EL PASO COUNTY PLANNING AND COMMUNITY DEVELOPMENT DEPARTMENT

PRELIMINARY DRAINAGE REPORT (PDR) CHECKLIST

Preliminary Drainage Report

The Shire at Old Ranch
PPR2410

Excluded Areas

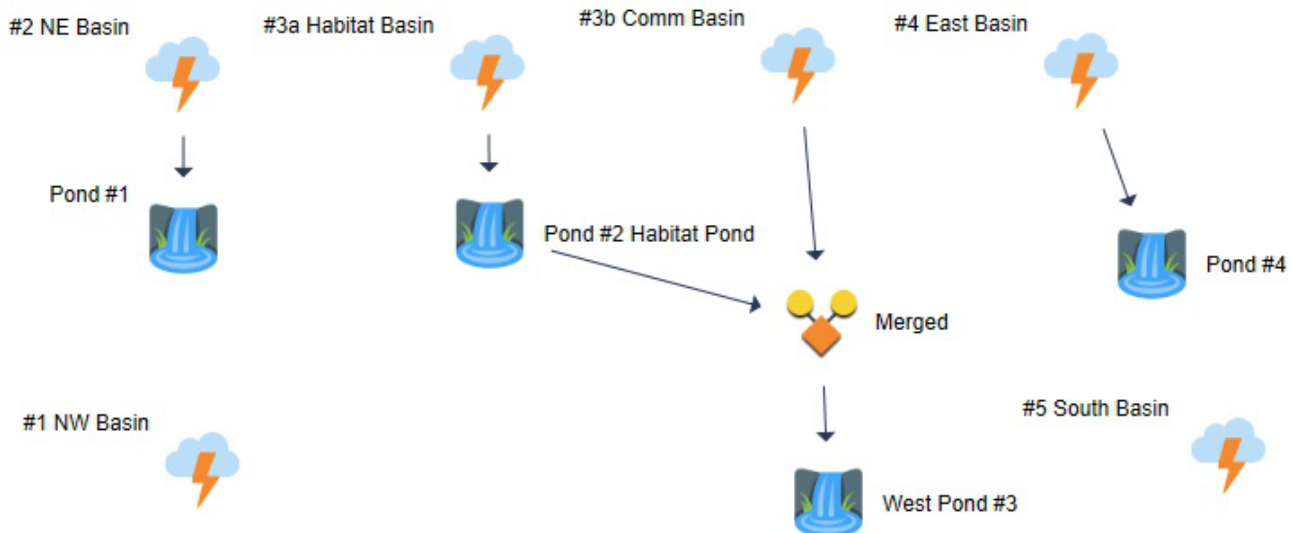
Site the applicable County exclusion. See ECM Section I.6 for all applicable PCM exclusions. Reference the exact exclusion and section

What other exclusion is being proposed? 3.44 ac is the total area and 2.25 ac are listed as undisturbed?

* Undisturbed land need not have PCM ?

Pond Report

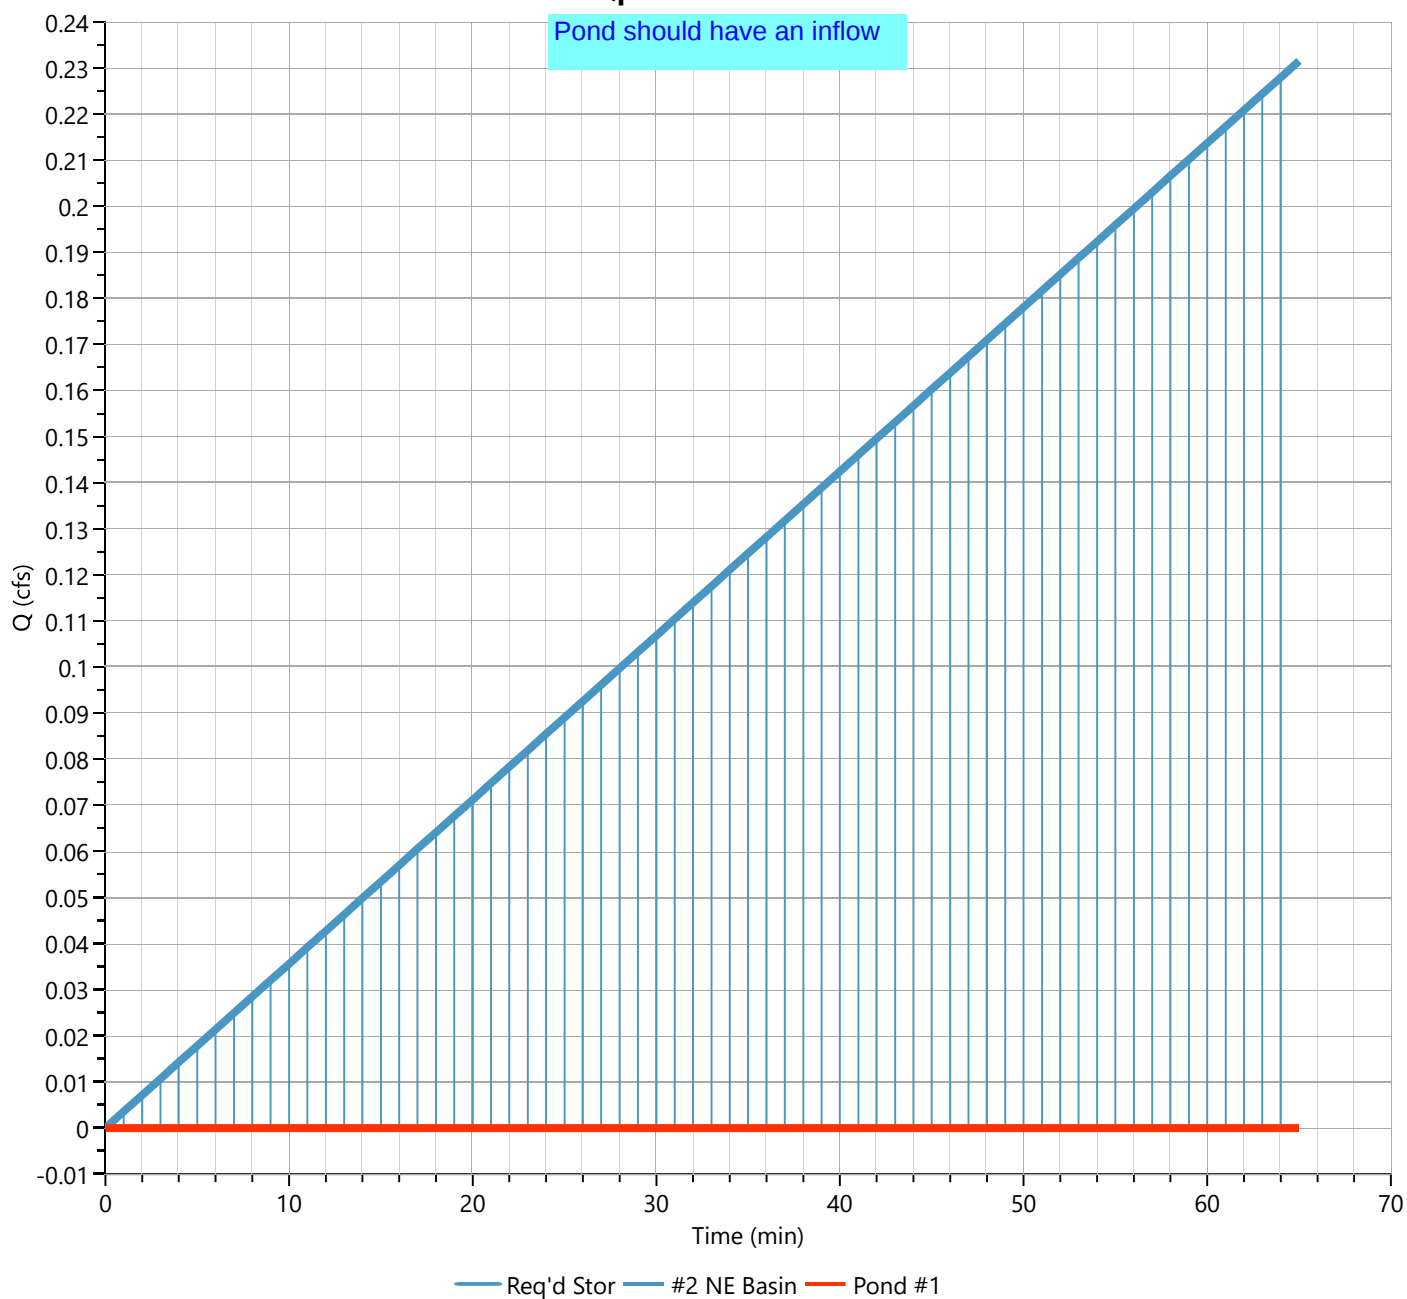
Pond should have an inflow

Clarify what 100% voids means. If this table is assuming the soil volume is 100% voids that could be contributing to a higher infiltration rate.

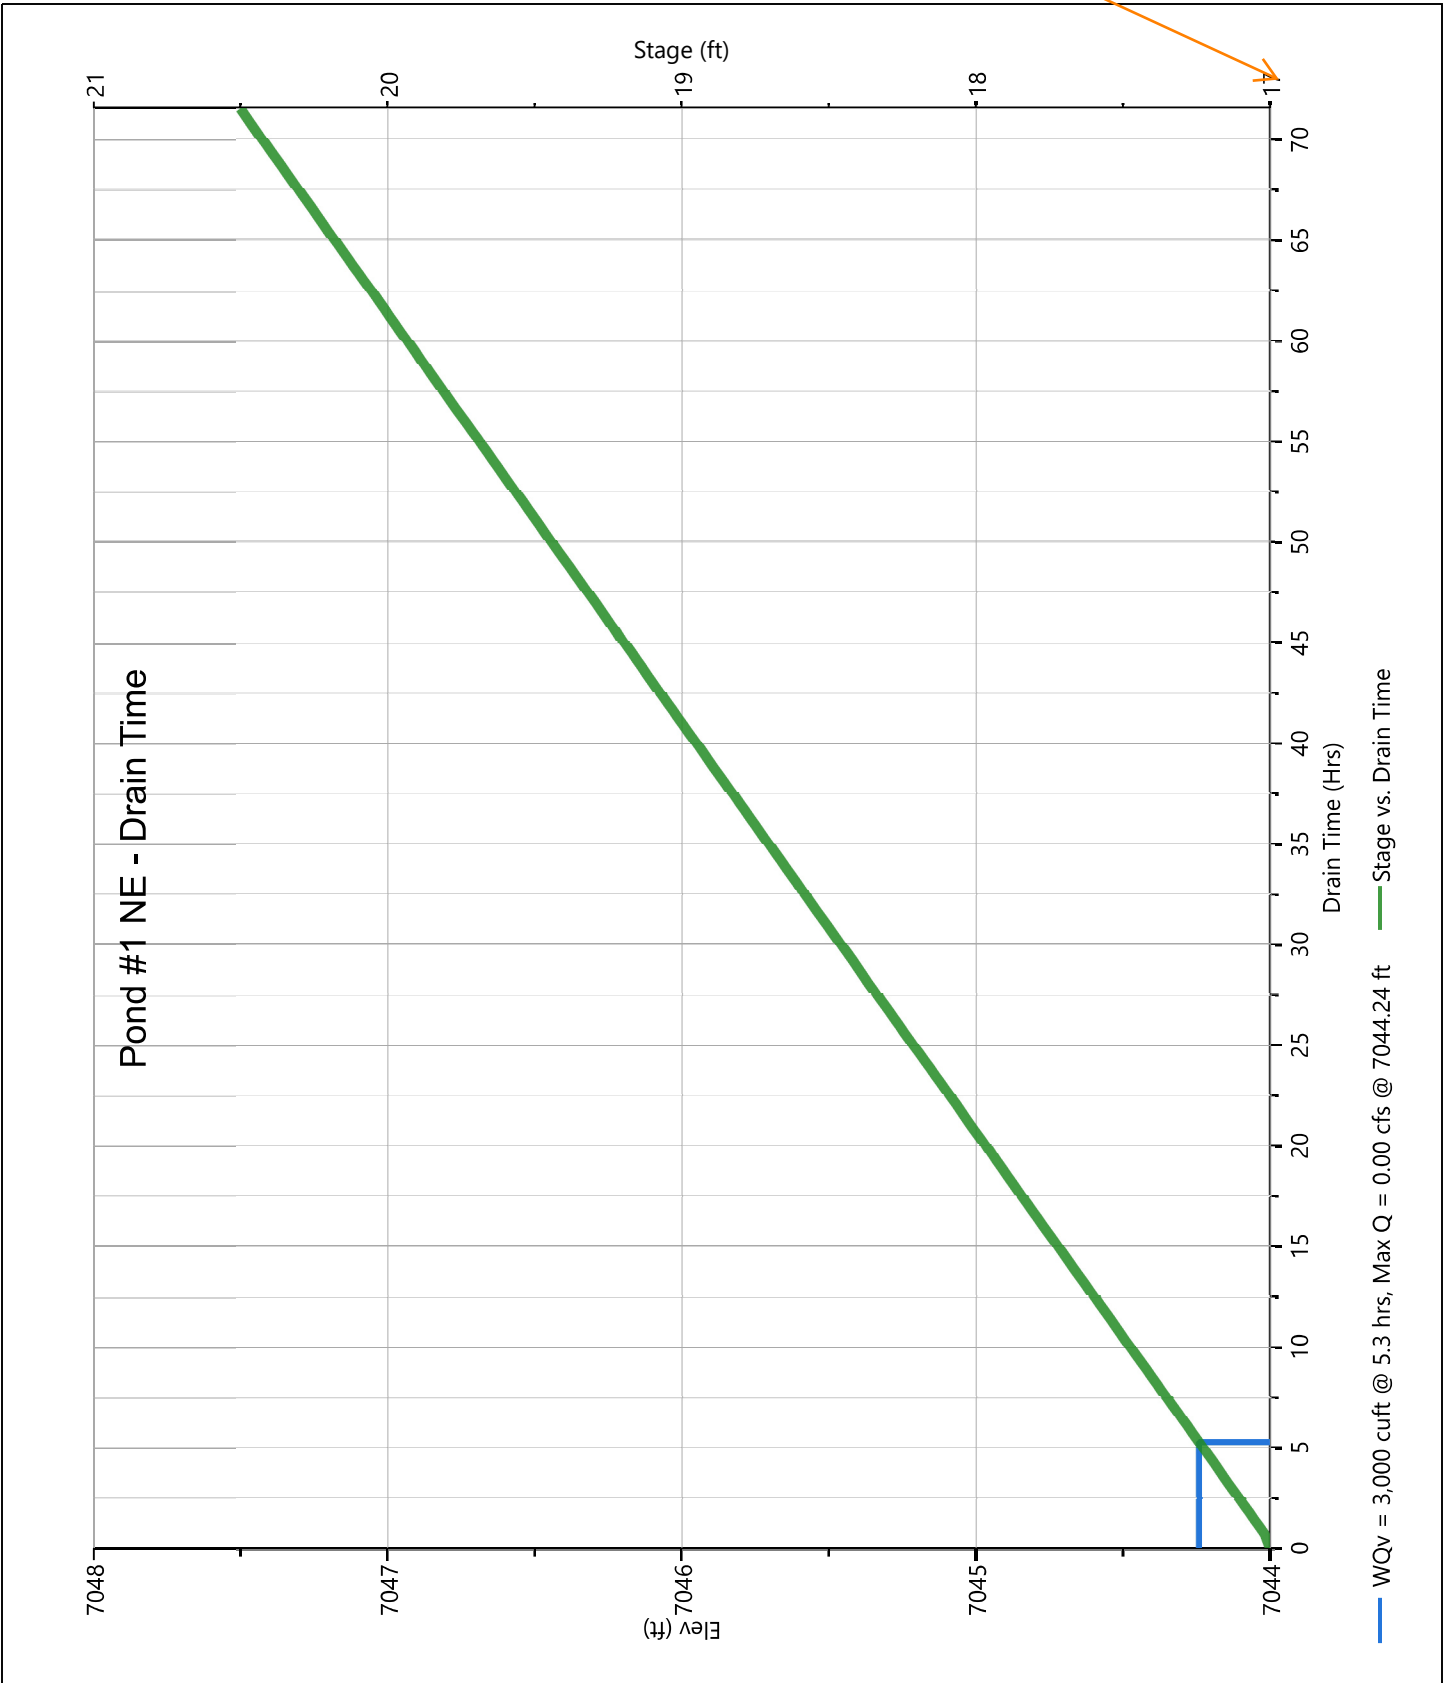
This should be stage = 0?

Pond #3 West Pond

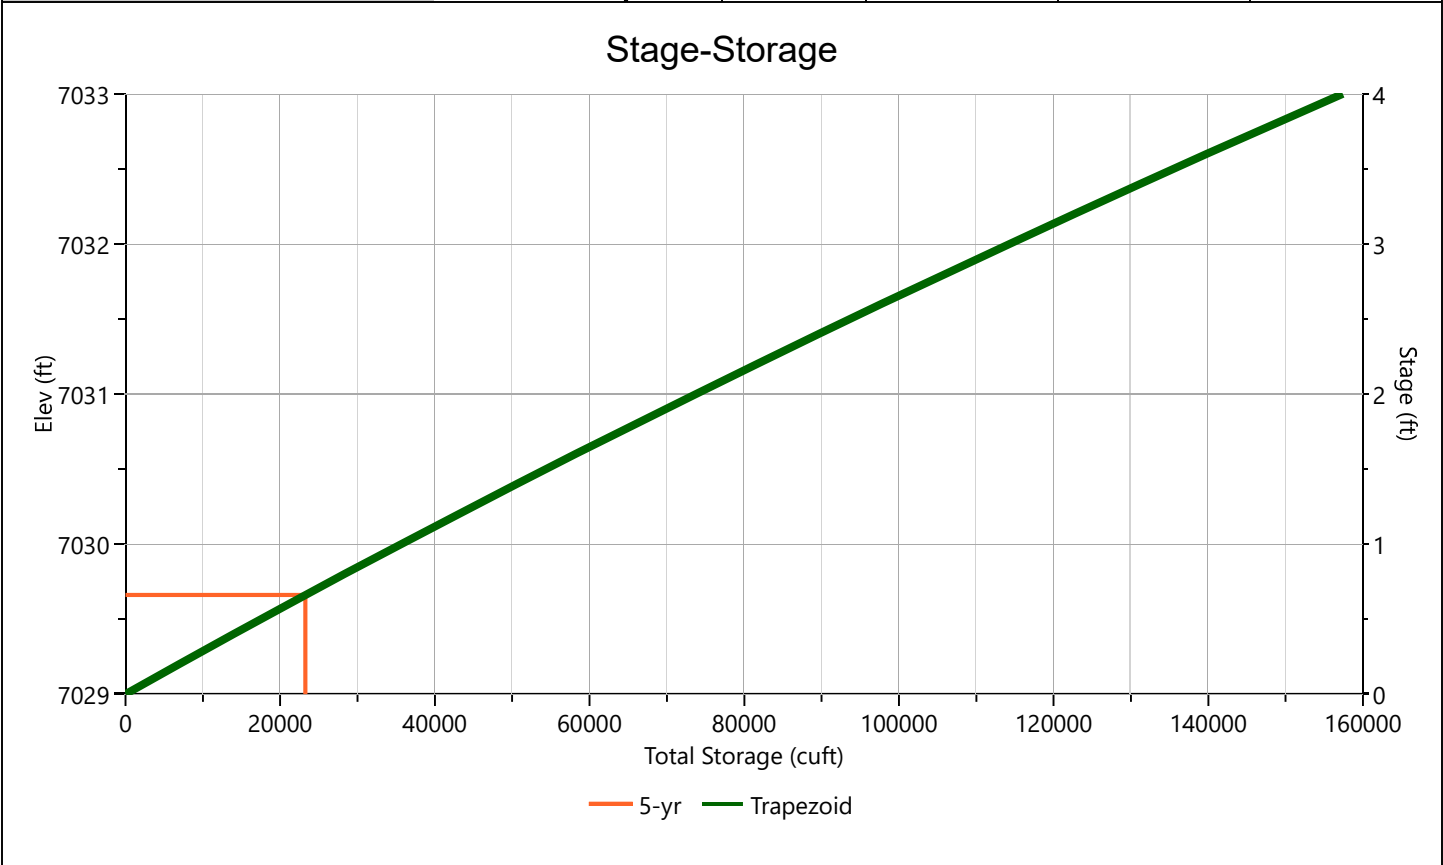
There should be some flow
into this pond. Please revise

DR -2
PCM Areas
Exempted

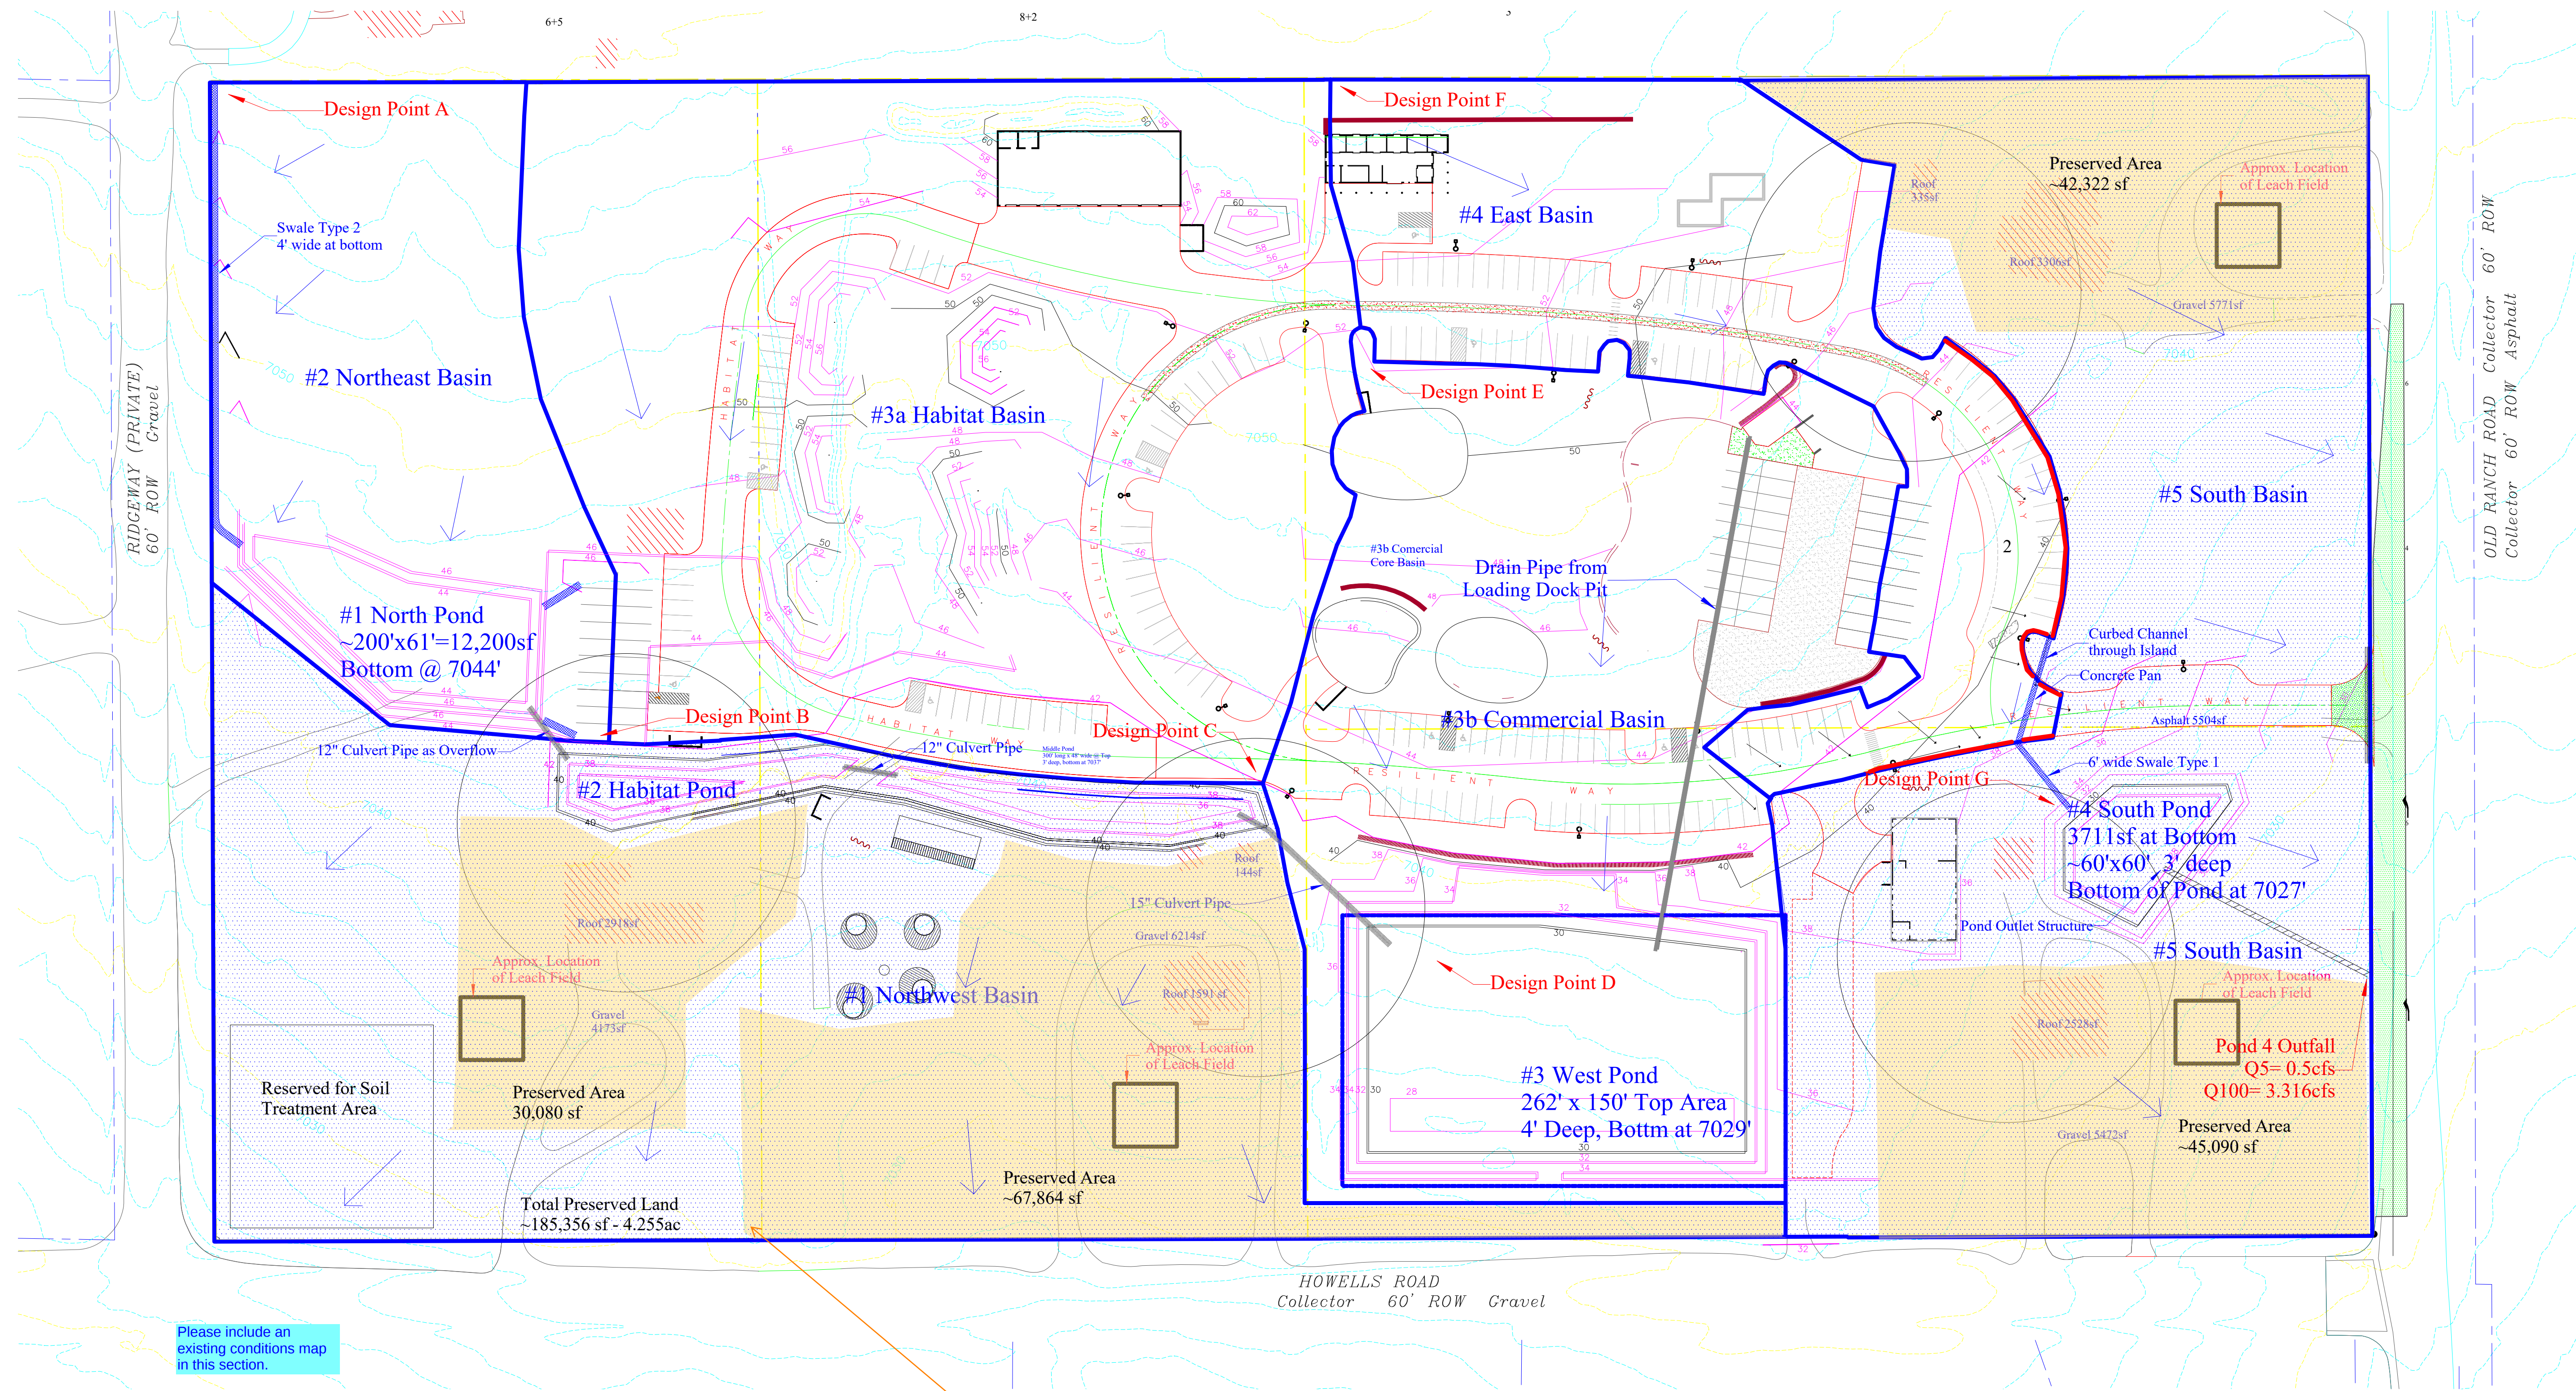
Provide legend for hatching areas
